Decision Maker: Environment Portfolio Holder

Title: GREENWICH TO KENT HOUSE QUIETWAY (BROMLEY SECTION) PUBLIC CONSULTATION REPORT AND FINAL PROPOSALS

London Cycling Campaign consultation response

Appendix 2 Lewisham Cyclists response

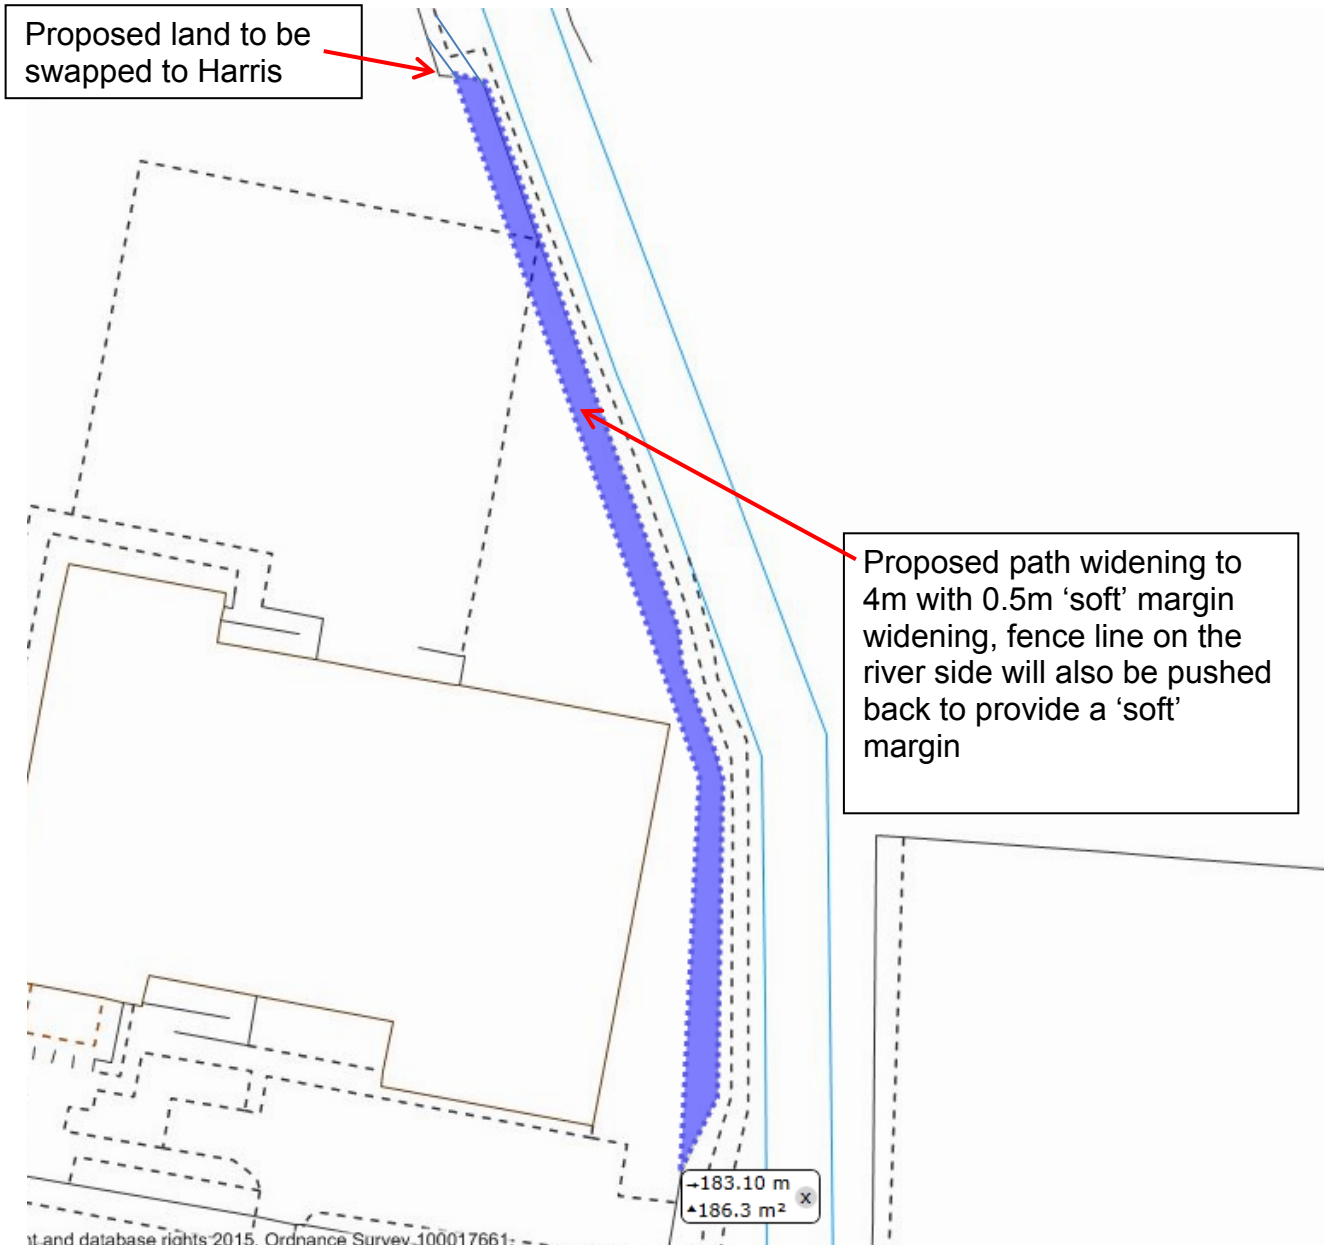
Appendix 6 Proposed land acquisition

- 186.3 sq.m. of land to be acquired from Harris Aspire
- 5.5 sq.m. of land returned to Harris Aspire
- Net acquisition of 180.8 sq.m. of land from Harris Aspire
